Adare Public Realm Upgrade Project 2026,
Adare, Co. Limerick.

STAGE 1 ROAD SAFETY AUDIT

Client	Limerick City & County Council
Project Title	Adare Public Realm Upgrade Project 2026
Project Location	Adare Village, Co. Limerick
Document Title	Stage 1 Road Safety Audit
Document No.	24015TT_MHL_AdareUR_Doc02-RSA-Rev C

2.1 Problem 1: An existing entrance not incorporated within design

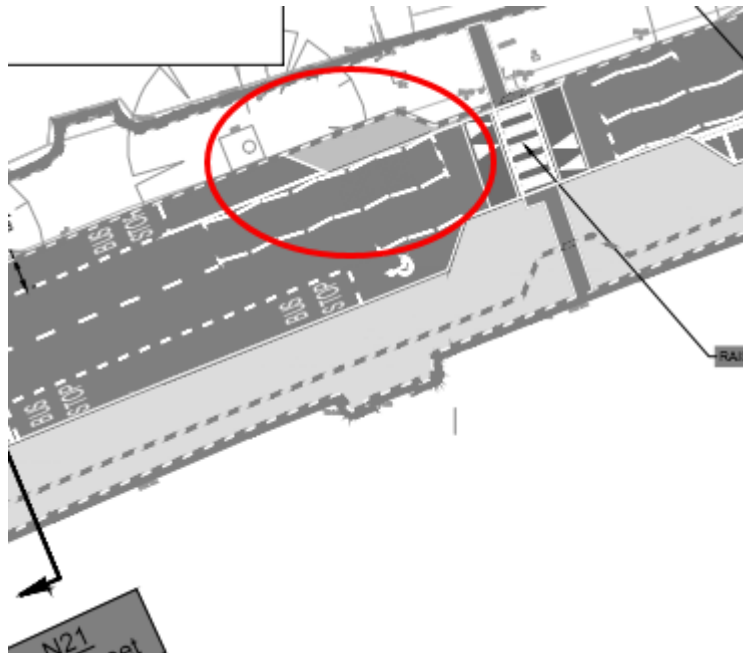
An existing vehicular entrance to the public car park does not appear to be incorporated into the proposed design. Failing to retain or incorporate existing entrances into design proposals can lead to conflicts between vehicles and pedestrians, as well as the potential removal of access. The proposed controlled pedestrian crossing, as identified, is also located in close proximity to the existing entrance.

Clarity should be provided by the design team if the identified existing entrance is being retained within the proposed design. If the existing access is being retained within the proposed scheme, the design team should consider the possibility of moving the proposed crossing away from this existing access. This measure would reduce potential conflict of traffic emerging from existing crossing and interacting with pedestrians accessing proposed crossing.

2.2 Problem 2: Potential hazard to vulnerable road users

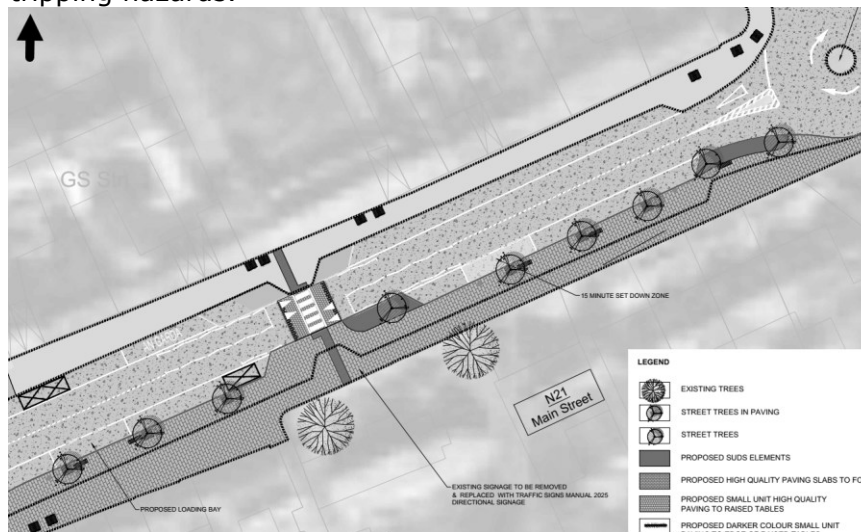
Non-linear landscape designs along Main Street could pose a potential risk to vulnerable road users. Such irregular planting may create confusion for these users and increase the likelihood of tripping hazards.

Provide suitable landscape proposals that are designed for all road users and do not create potential hazards to vulnerable road users. Any redesign and repositioning of landscaping to the forefront of footpath should align with RSA Problem 2 listed previously.

2.4 Problem 4: Conflict between proposed general arrangement and landscaping proposals

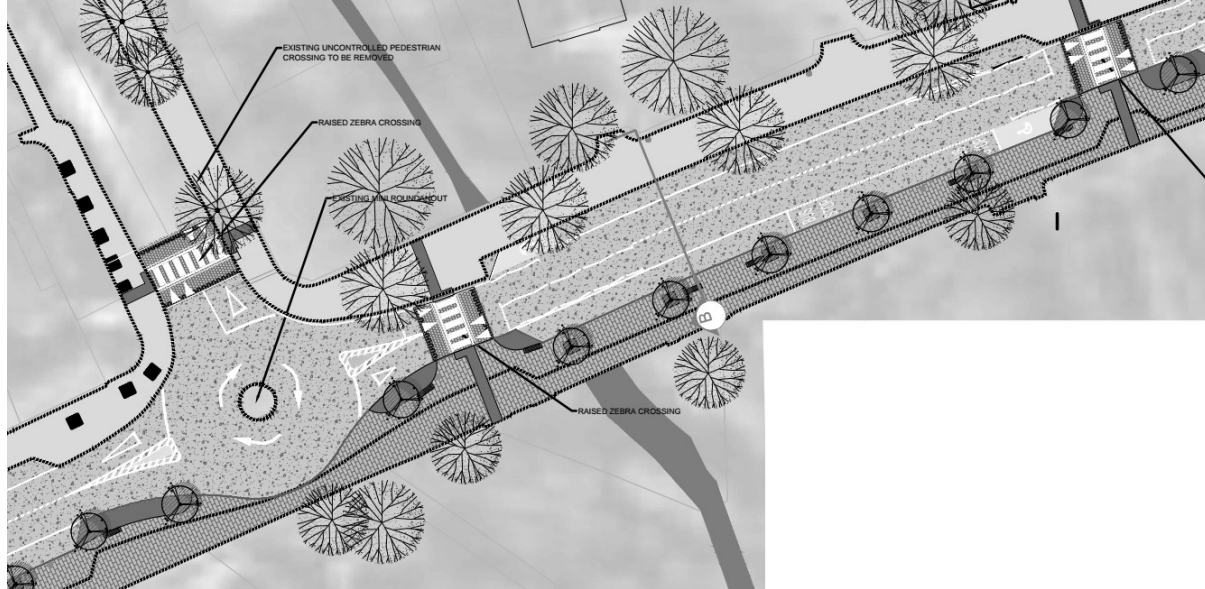
It is evident from the drawing issued that a conflict has occurred within the Proposed Parking Layouts and the Proposed Landscape Plans. There seems to be a conflict with proposed parking bays and proposed softscape areas. This may lead to illegal parking within softscape areas which overtime may become unsightly.

Review proposed scheme layouts & landscape plans to ensure conflicts between softscape areas and parking bays do not occur within the scheme.

2.12 Problem 12: Excessive crossing widths at heritage centre

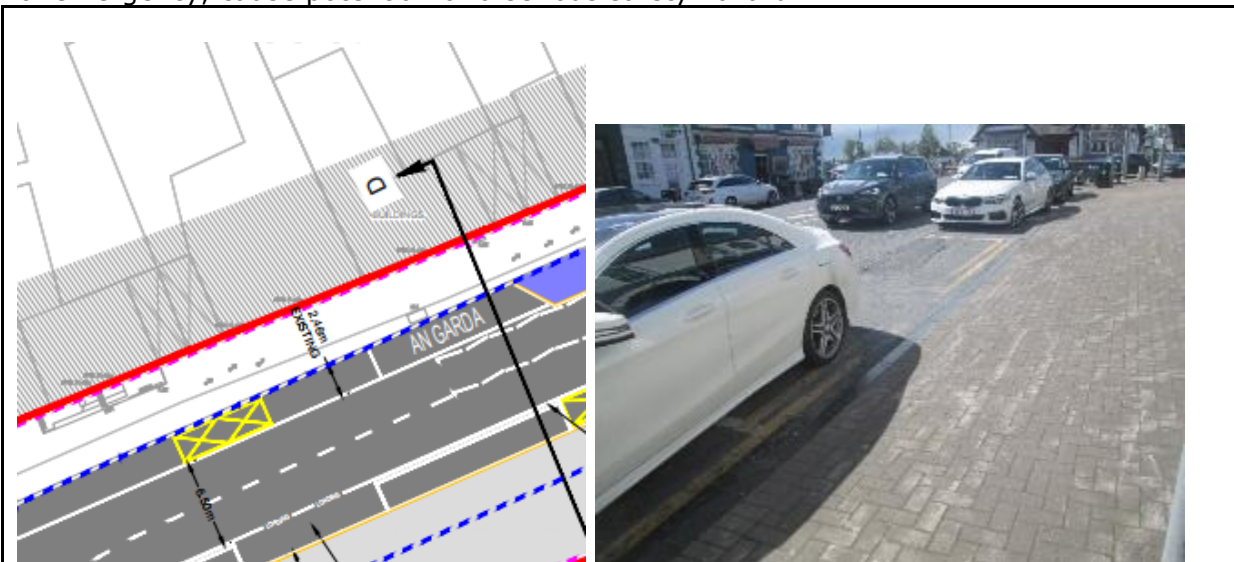
Existing pedestrian crossing widths were observed at the entrance/exit from Heritage Centre car park. Excessive entrance/exit carriageway widths can promote high entry and exit speeds from vehicles at the junction. Excessive speeds and crossing widths can create a major hazard and result in potential collisions between cars/buses and pedestrians.

The design team should consider reducing the junction radii at this location and/or consider the possibility of introducing a raised entry treatment to reduce traffic speeds and increase the safety of pedestrians.
